CCC Interrogatory #063

Exhibit E1, Tab 1, Schedule 1, pp. 6-7

Chart 1
Niagara River Flows – Actual & Forecast (2020-2027)

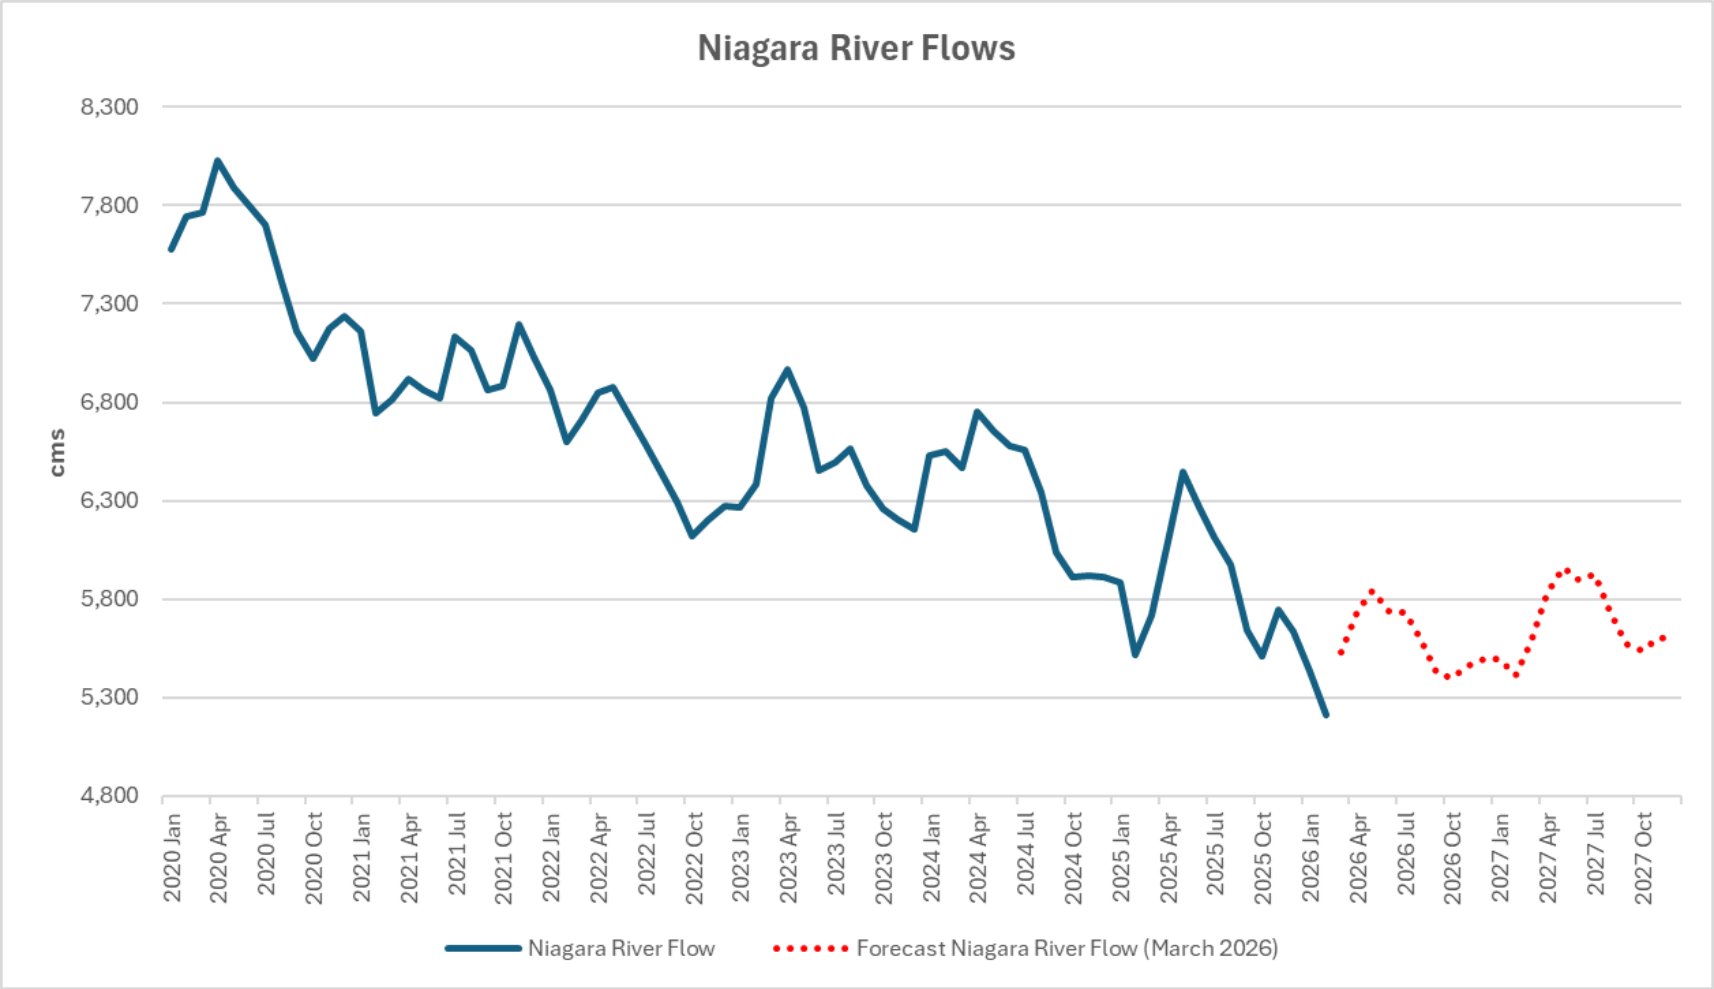
- v) For hours where the PGS pump is not running at full capacity despite SBG conditions, a listing of all the reasons why that is not the case.
- b) OPG states: "OPG attributes the increase in PGS utilization and the concomitant decline in hours with SBGVA bookings when the PGS is not pumping to the absence of very high flows on the Niagara river and sufficient price spread in the market." Please provide a table of data to illustrate the change in flows and a forecast of the same data over the next five years. Please also provide a qualitative response regarding the expected flows in the coming years.

- 18 b) Refer to Chart 1 below.
19

20 The Niagara River experienced a period of higher-than-average flows from 2017 to
21 2023. The high flows peaked in 2020 and then began to return to the long-term
22 average. At the time of this response, Niagara River flows are below long-term
23 average. The 2027 test year Niagara River production forecast is based on long-
24 term average flows.

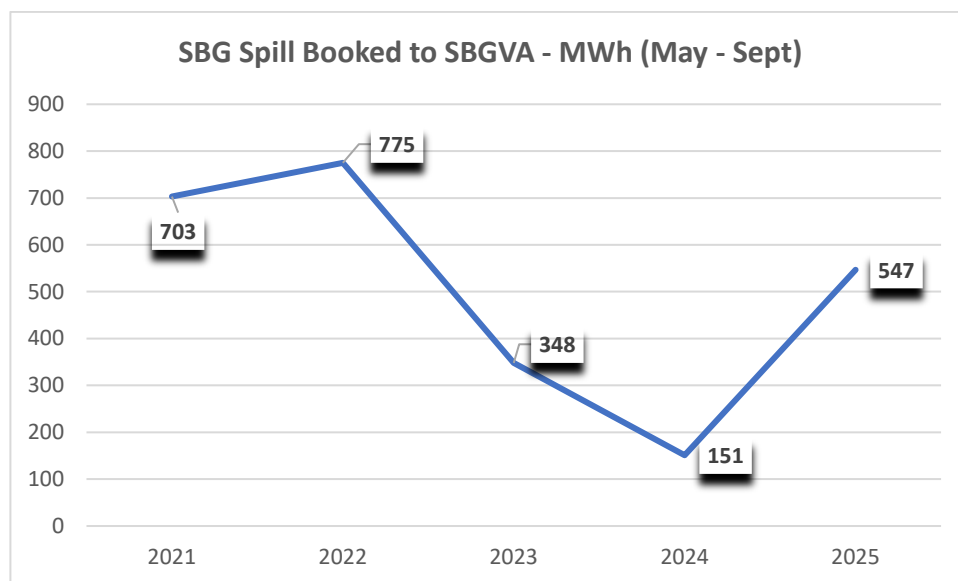
Reference 1, OPG notes that “Under the Renewed Market, spill volumes observed to date have remained generally consistent on a month-over-month basis with levels recorded since 2021.”

At Reference 2, OPG provided a table that sets out “SBG Spill Booked to SBGVA (MWh)” on a monthly basis, for 2021 – 2025.

OEB staff focused on comparing the same subset of months that Surplus Baseload Generation (SBG) spill data was provided by OPG for the Renewed Market (May to September) across all the years. That is reflected in the chart below which shows the amount of SBG spill booked to the Surplus Baseload Generation Variance Account (SBGVA) declining substantially in the years before Market Rate Program (MRP) was implemented – from 2021 & 2022 (both years over 700 MWh) to 2024 (151 MWh). In the months following MRP Go-Live, it then increased considerably (547 MWh).
